ENERGY NORTHWEST

Subject: **WNP-2, OPERATING LICENSE NPF-21
REQUEST FOR AMENDMENT
TECHNICAL SPECIFICATION 4.3.1.2.b
(ADDITIONAL INFORMATION)**

Reference: Letter, dated January 3, 2000, Jack Cushing (NRC) to JV Parrish (Energy Northwest) "Request for Additional Information (RAI) for WNP-2, (TAC NO. MA7228)"

**REQUEST FOR AMENDMENT TECHNICAL SPECIFICATION 4.3.1.2.b
(ADDITIONAL INFORMATION)**

NEW FUEL VAULT - DIAGRAM 2

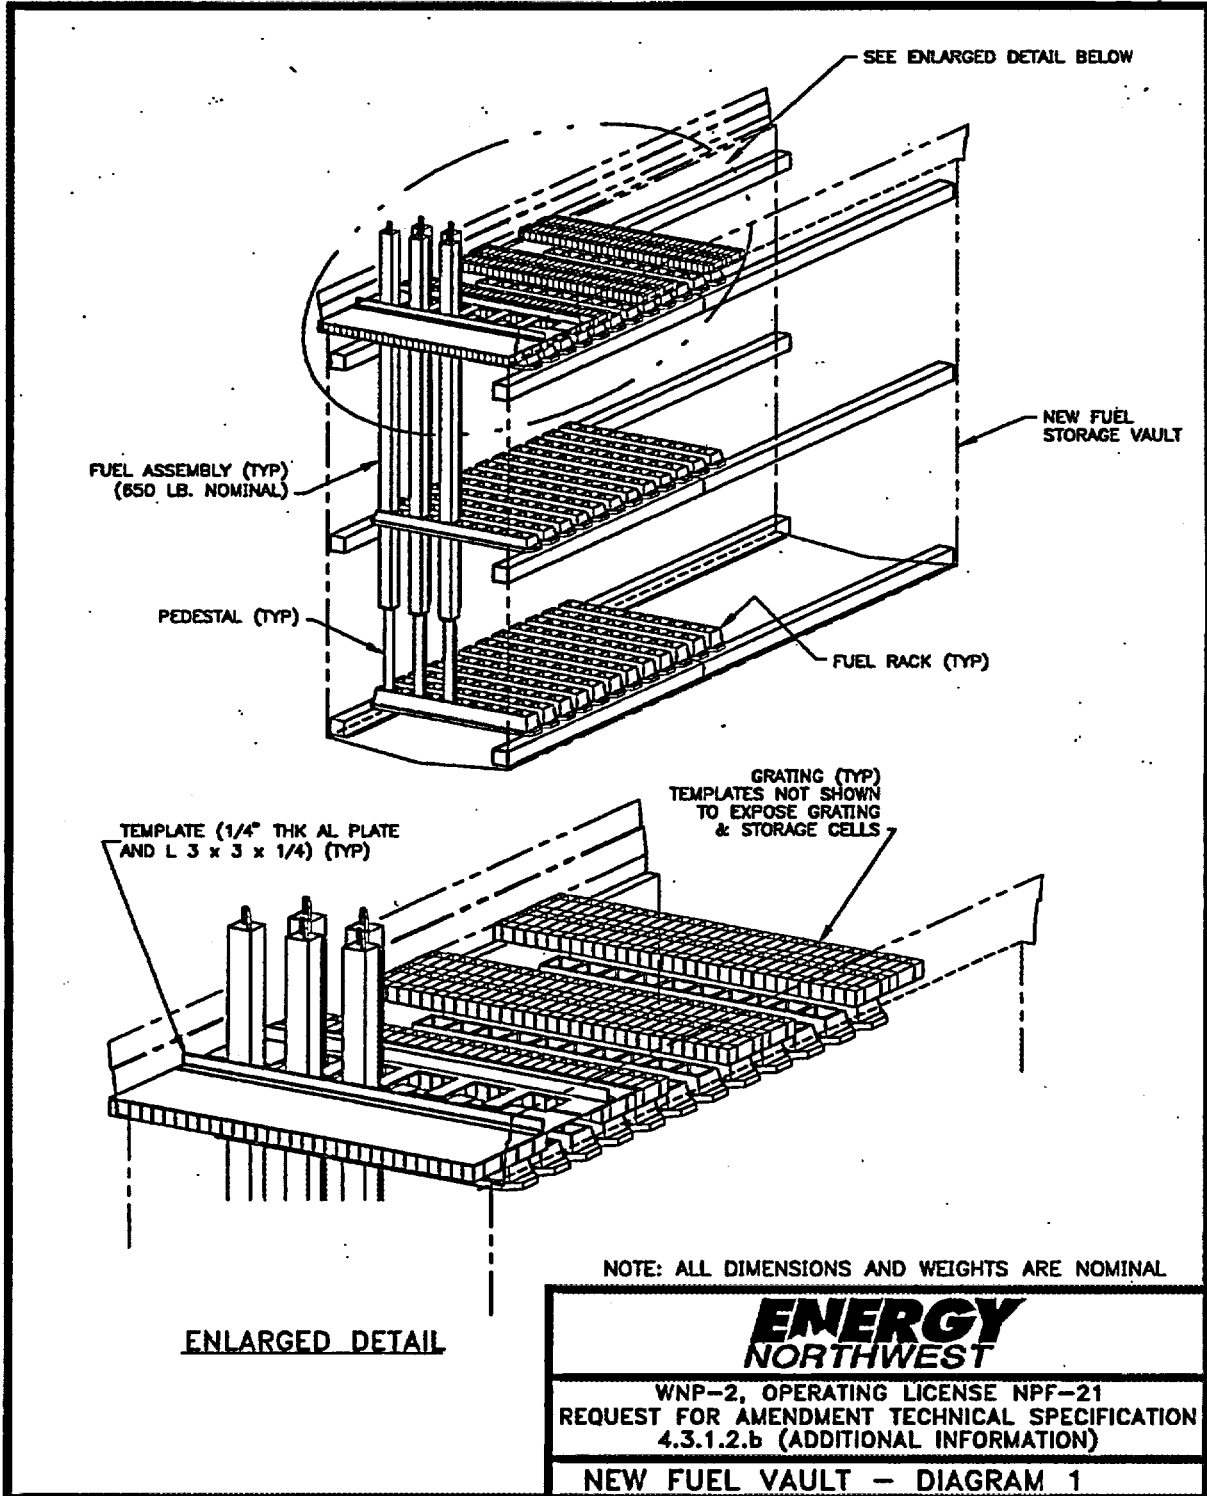
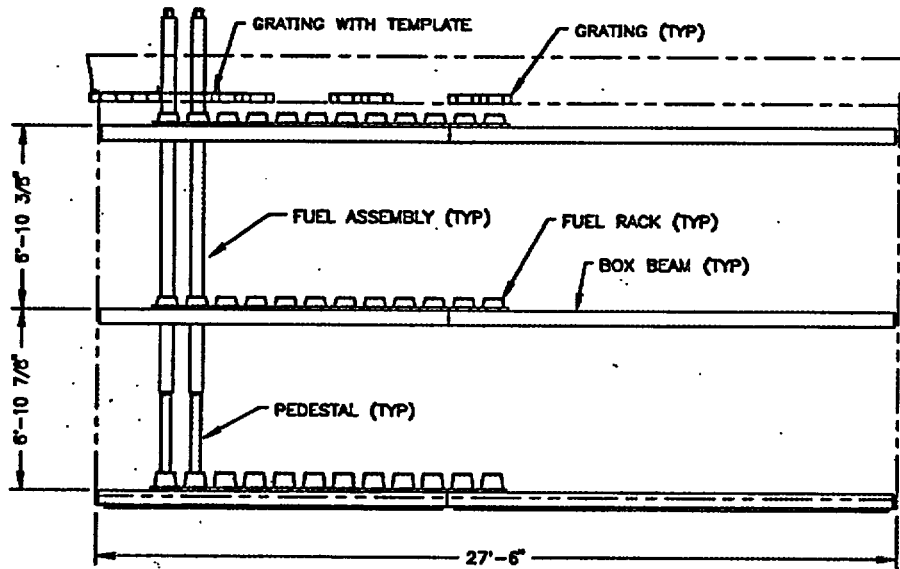
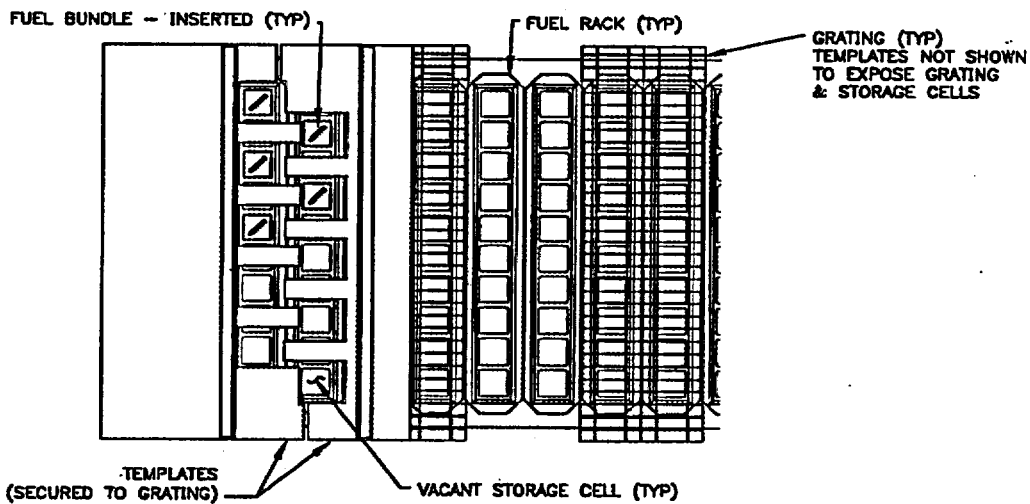
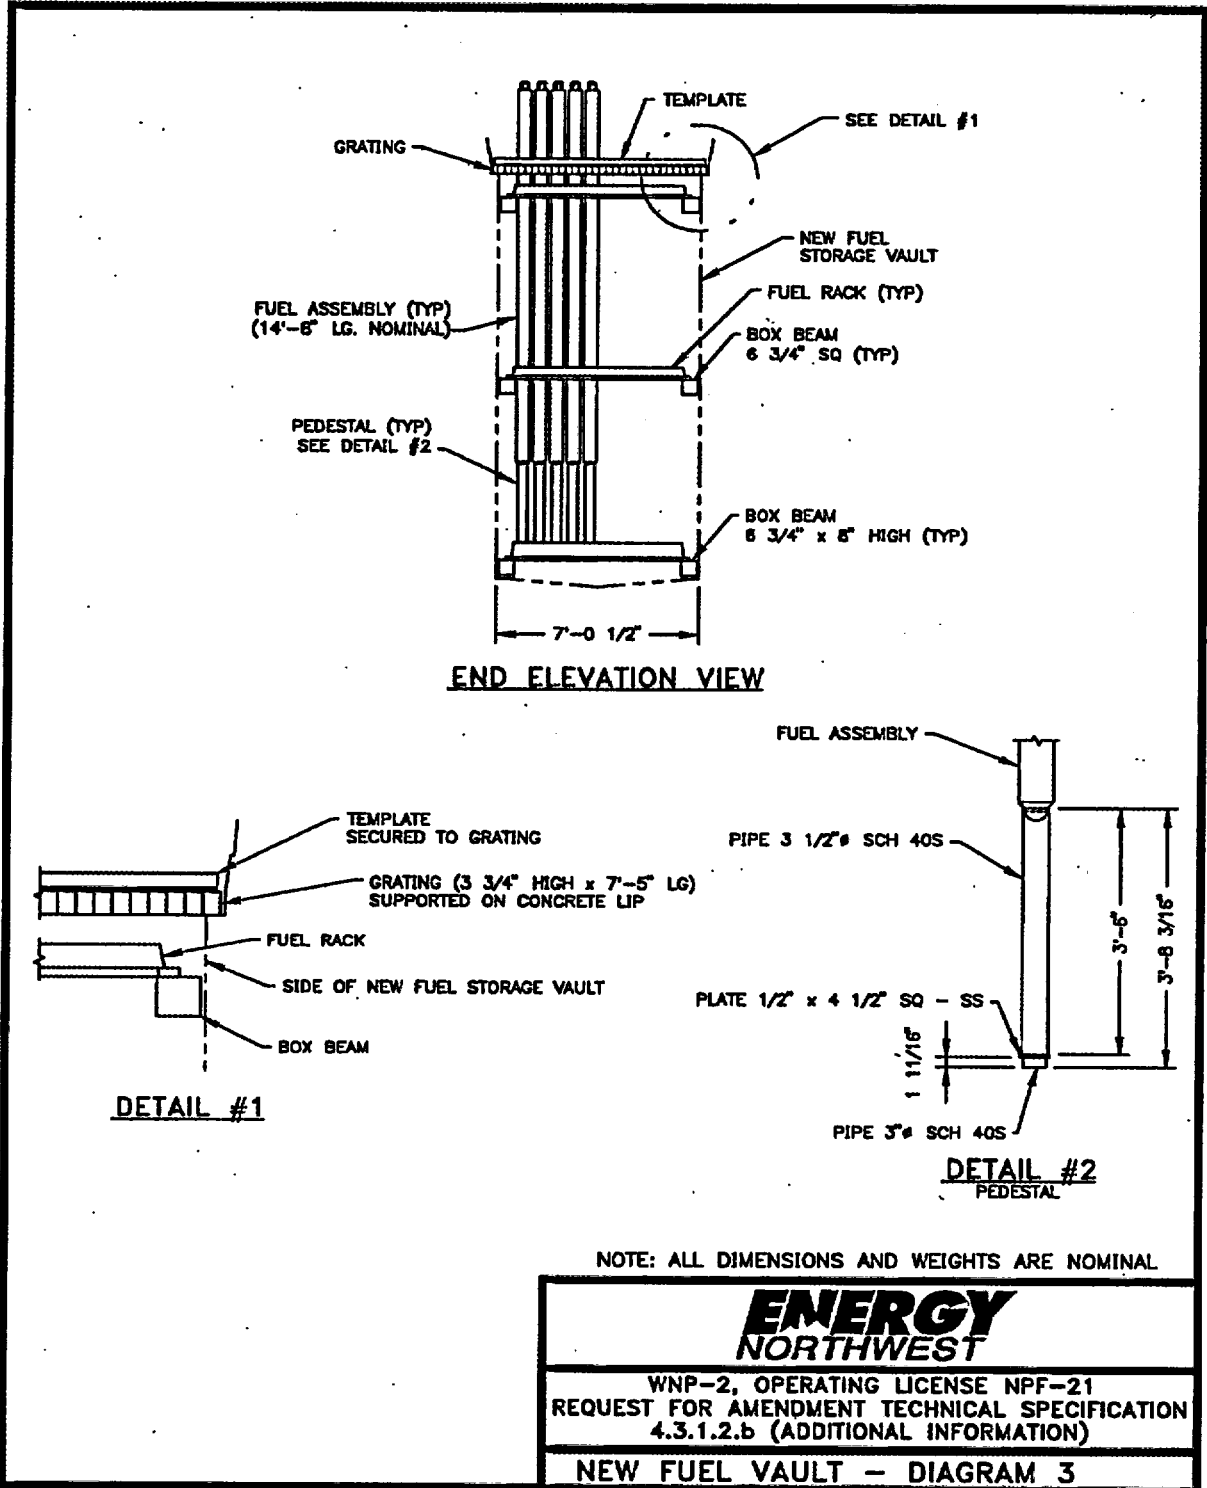
Discuss briefly the types of analyses (including any seismic dynamic analysis) performed to determine the structural integrity of the various elements affected by the new geometrical limitations for storage of new fuel assemblies in the new fuel racks. This discussion should include the analyses related to the accidental drop of the fuel assemblies being supported by the pedestal.

Provide a summary of the results of the above analyses and confirm that the (strength) "capacities" of the various structural elements (e.g., the pedestal, vault floor, rack walls, cover plates, etc.) are adequate to satisfy the demand imposed on them by the new configuration of the fuel assemblies as per the applicable industry codes.

A structural analysis has been performed to verify the structural integrity of the new fuel racks resulting from the new geometrical limitations of the new fuel rack support system. See attached diagrams of new fuel storage rack arrangement. The configuration control components used in the new fuel vault consist of a series of templates and working platform grating sections and a fuel support assembly (pedestal).

an assembly is fully inserted. To address the potential for uplift of a fuel assembly mounted in the pedestal, a review of the floor response spectra and a calculation of the lower fuel rack beam was performed. The vertical load on any lower fuel rack beam is reduced to less than 55% of the original load (i.e., one half of the weight of the original number of fuel assemblies, plus the weight of the pedestals). Based on a conservative natural frequency and response spectrum analysis, the forces from a safe shutdown earthquake for the new fuel assembly support system are below 1.0 g in the vertical direction. Thus, no vertical uplift of the fuel assembly will occur and the implementation of this tool (pedestal) will not have an adverse structural impact (vertically).

To address the potential for lateral load increases due to the elevated fuel assemblies (through the use of pedestals), an analysis was performed comparing the original and elevated fuel assembly configurations. The proposed fuel storage limitations and the template assure only half (every other one) of the designed number of new fuel assemblies are placed in a row. The original design used three levels of fuel rack beams to carry the lateral load of fuel assemblies resulting in $\frac{1}{2}$ of the fuel assembly lateral load being carried by the center fuel rack beam and $\frac{1}{4}$ of the lateral load being carried by the other two fuel rack beams. When the 42 inch pedestal is used, only the center and upper fuel rack beams are assumed to carry the lateral load. However, since only half of the fuel assemblies are allowed (from that originally designed), the resulting lateral loads on each of the beams will be equal to (on the upper fuel rack) or less than (on the center fuel rack) the original load. This maintains adequate design margins for fuel rack loads.

The proposed limitations result in a new configuration of fuel assemblies that consists of only $\frac{1}{2}$ the number of original design fuel assemblies in a single fuel rack row and $\frac{1}{4}$ of the total number of original design fuel assemblies in the new fuel vault. This is a significant load reduction and a key to assuring that the strength capacities of various structural components are adequate. The templates and working platform gratings are supported independently from the fuel assembly racks and do not affect the strength of the new fuel rack structural elements. Therefore, the use of templates for loading configuration control and the use of pedestals do not result in load increases to the vault floor, rack walls, or other rack components. Furthermore, the strength capacities of FSAR Table 3.9-2s are maintained.
